Item ID: D3290-3

Item Name: Window

DART AEROSPACE LTD	Work Order:	67550
Description: Window	Part Number:	D3290-3
Inspection Dwg: D3290	Rev: C	Page 1 of 1

DRAWING NO. D3290	TITLE REPLACEMENT WINDOW ASSEMBLY	REV. C	DART AEROSPACE LTD ENGINEERING ORDER	D.E.O. NO. D3290-C-1	SHEET NO. SHEET 1 OF 1	SCALE NTS
DRAWN <i>gp</i>	CHECKED <i>ls</i>	MFG. APPR. <i>EZ</i>	APPROVED <i>WJ</i>	DE APPR. <i>WT</i>		
DATE 09.09.18	DATE 09.09.18	DATE 09.09.18	DATE 09/09/21	DATE 09/09/21	DATE 09/09/21

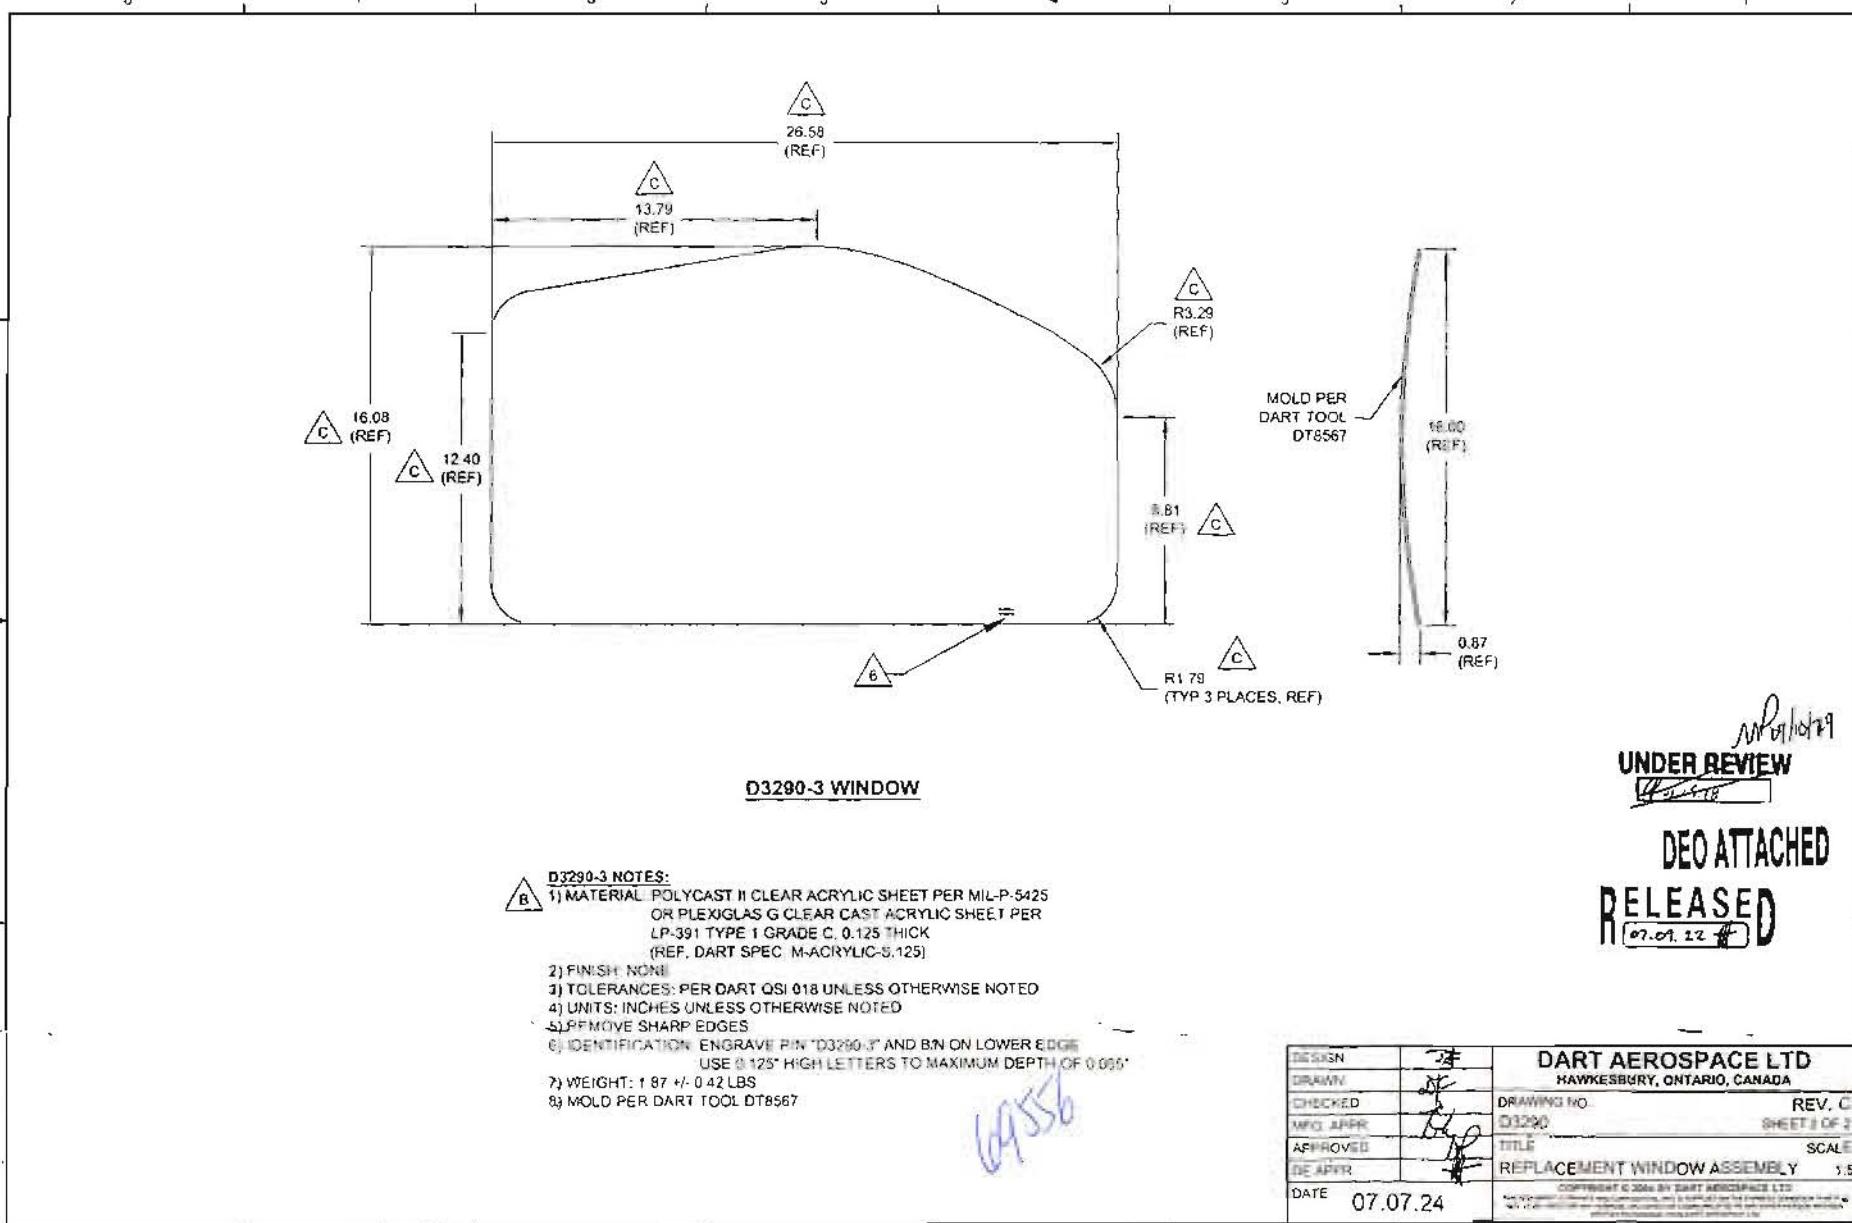
CHANGE MATERIAL THICKNESS OF D3290-1 FRAME TO 0.063 FROM 0.040. REF PAR 09-033.

MATERIAL CALL-OUT OF D3290-1 FRAME ON SHEET 1 IS AMENDED AS FOLLOWS:

- 1) MATERIAL: 6061-T6 (OR 6061-T62) ALUMINUM SHEET ~~0.040 THICK~~ 0.063 THICK (REPLACE)
PER AMS-QQ-A-250/11 OR AMS 4025 OR AMS 4027
(REF. DART SPEC. M6061T6S.040) REF. DART SPEC. M6061T6S.063 (REPLACE)
OR
5052-H32 ALUMINUM SHEET ~~0.040 THICK~~ 0.063 THICK (REPLACE)
PER AMS-QQ-A-250/8 OR AMS 4016
(REF. DART SPEC. M5052H32S.040) REF. DART SPEC. M5052H32S.063 (REPLACE)
